**Florida
Power**
CORPORATION

May 23, 1988
3F0588-10

Subject: Crystal River Unit 3
Docket No. 50-302
Operating License No. DPR-72
Control Room Habitability
NUREG 0737, Item III.D.3.4
Request for Additional Information (TAC No. 64805)

TABLE 1
CR-3 PLANT TOXIC GAS HAZARDS
ALLOWABLE LIMITS

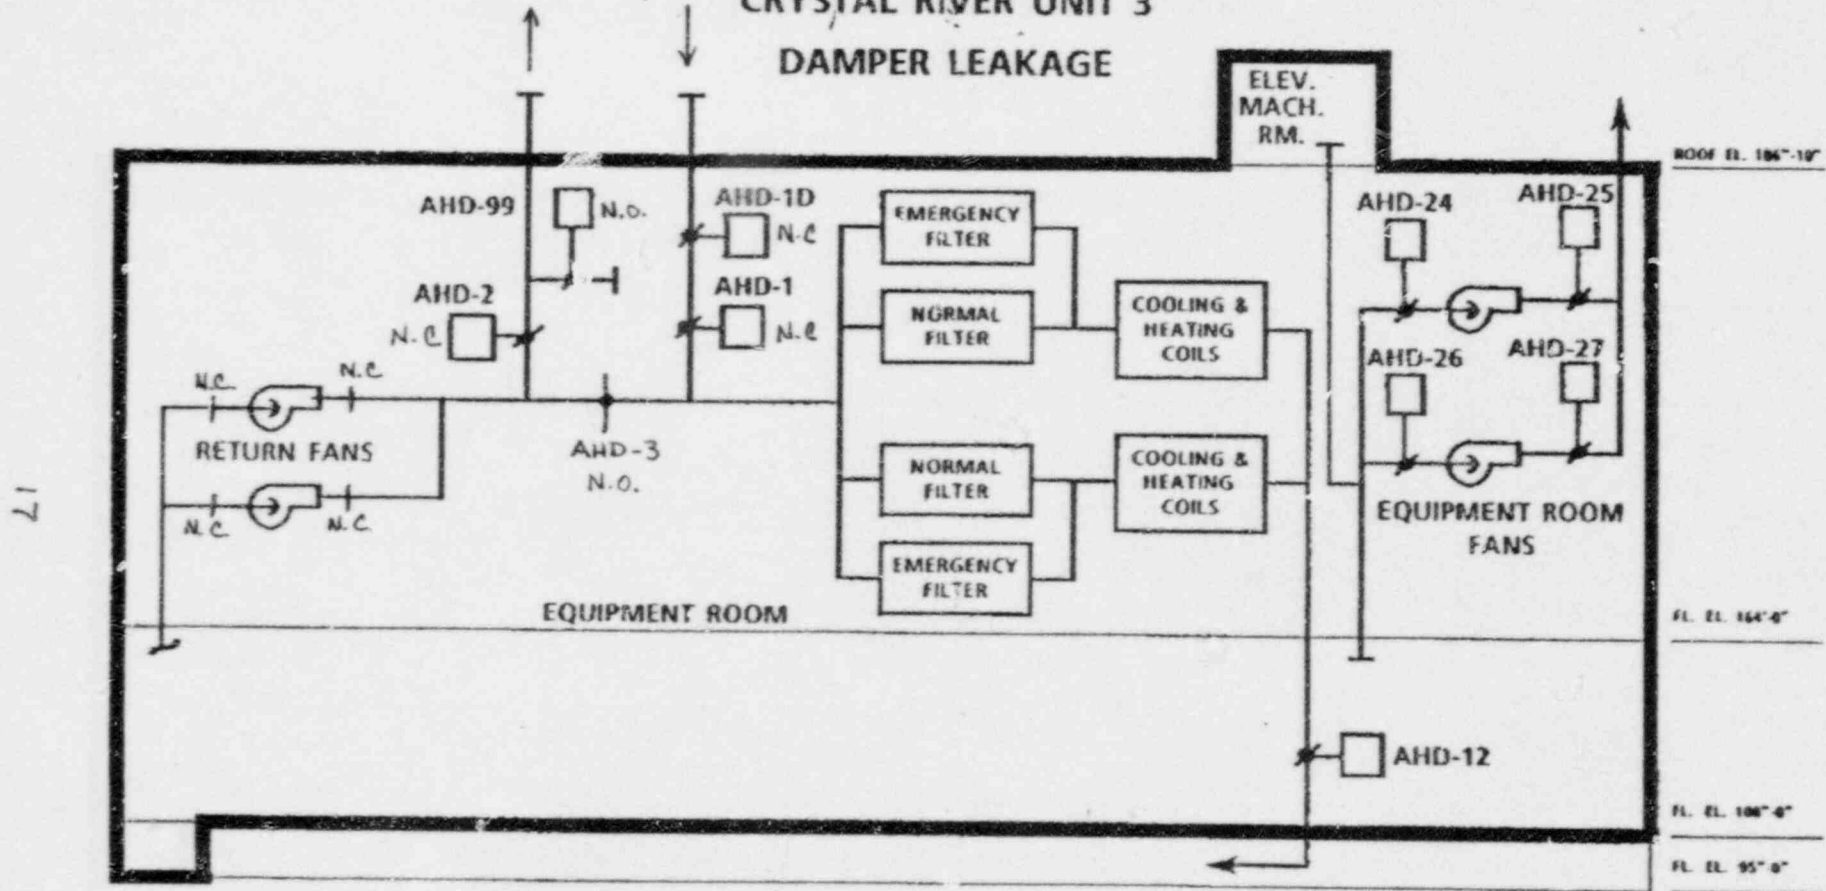
FPC's submittal to the NRC dated June 30, 1987 identified chlorine (Cl₂), sulfur dioxide (SO₂), and ammonia (NH₃) as potential toxic gas hazards that require consideration in evaluating the Crystal River Unit-3 (CR-3) Plant control room habitability. The allowable limits, as defined in SRP Section 6.4, used by FPC as a guideline in evaluating these potential toxic gas hazards, are summarized below. The bases for the selection of these limits are discussed below for each of the toxic gas hazards.

As noted in our previous submittals and discussions, the protective action limit of 5 ppm provided in RG 1.78 for SO₂ is not considered to be appropriate nor consistent with either the RG 1.78 toxicity limit definition, the SRP 6.4 allowable limit determination guidelines, or industrial science.

However, because of the sensitivity of the limit issue, additional data on SO₂ effects were consulted (Ref. 3 and 4). The Reference (3) Methodology results in a limit of 36 ppm to be used as the Emergency Exposure Limit (EEL) as defined by the Committee on Toxicology of the National Academy of Sciences: "The EEL for short-term exposure to an airborne contaminant is a concentration which when inhaled for a specified single, brief period rare in the lifetime of an individual is believed not to result in a period of disability or interference with the performance of his assigned task." This EEL value was determined based upon methods presented in reference (3) which proposes that the EEL be calculated by 0.3 of the RD₅₀ value (where RD₅₀ is the concentration of a sensory irritant at which a 50 percent decrease in respiratory rate occurs, i.e. 120 ppm for SO₂).

This concentration (120 ppm) is the value at which toxic effects could be incurred with extended exposure to SO₂ and is also considered to be immediately dangerous to life or health in the general literature. Based upon this data, the FPC acceptance limit has been changed to 36 ppm for SO₂.

Reference (3) proposes that the short-term exposure limit (STEL) be based upon a value equal to 0.2 of the RD₅₀ (24 ppm). However, due to differences in the defined exposure period for occupational STEL (15 minutes exposures, 4 excursions per day) versus the SRP 6.4 accident STEL (2 minutes to 1 hour) as well as reported effects at this concentration, a short-term limit value equal to 0.1 RD₅₀ (12 ppm) was selected.

FIGURE 4.1
TYPICAL PENETRATION SEALS
WITH SEALANT CAULKING

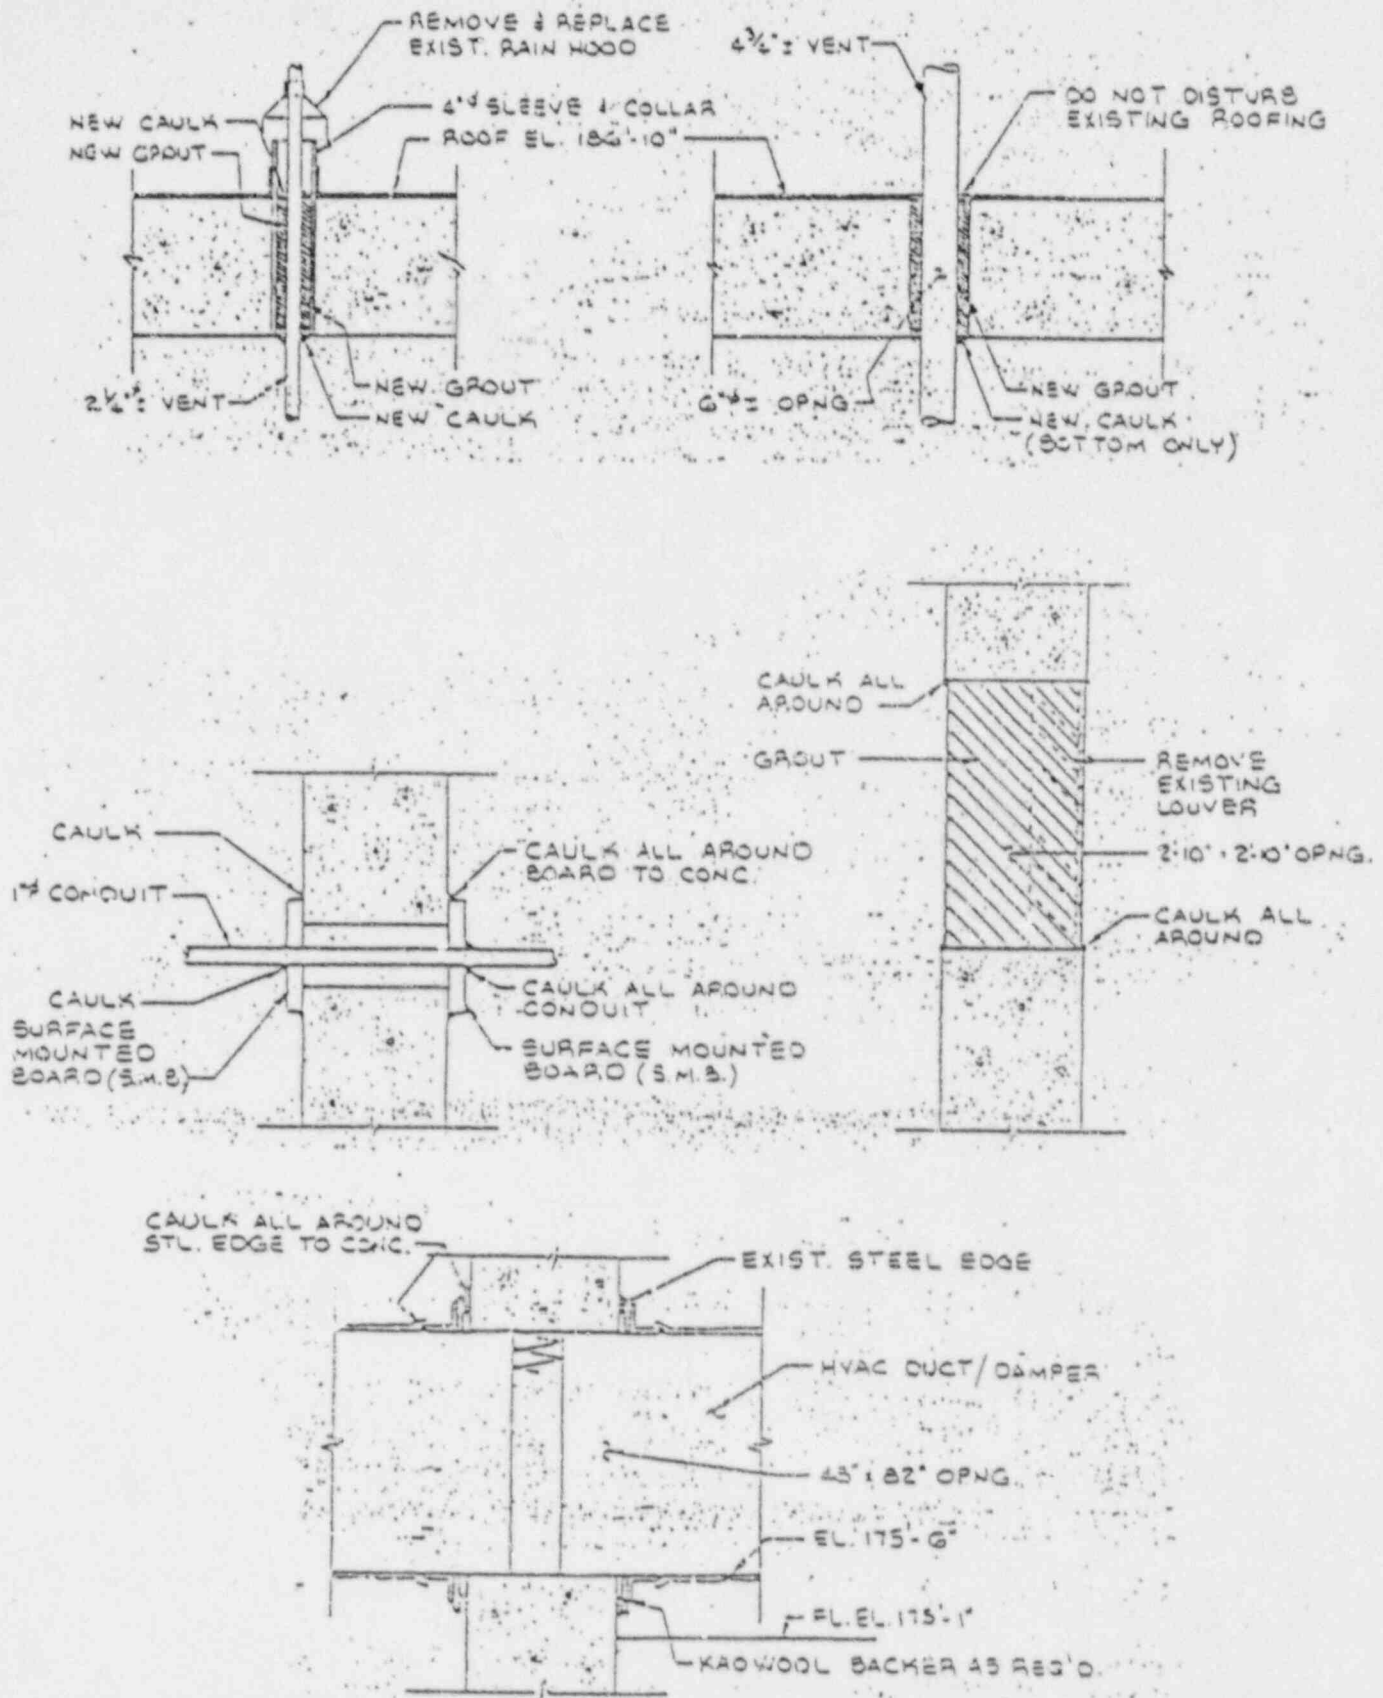
The following additional information is provided to support the use of "SILASTIC" 732 RIV Adhesive/Sealant to reduce air in-leakage to the CRE at penetration seals.

As a conservative redundancy to the penetration air seals design, the sealant caulking is provided on each face of typical penetrations. Typical penetration sealing details where sealant was utilized are shown in attached Figure 4.1.

In this particular application, the sealant is used as an edge and surface caulking in non-working joints, i.e. no movement. The very minor pressure due to 1/8 inch water gauge pressure differential causes negligible stresses in the sealant used as a caulking at contact joints between materials forming the penetration seal. Where the sealant is used as caulking at ductwork penetrations, stresses in the sealant due to vibration are not anticipated for the following reasons: HVAC equipment to which the ducts attach are mounted on vibration isolation devices. Second, flexible joints are included in the ductwork in close proximity to the connected equipment further isolating any equipment vibration from the ductwork.
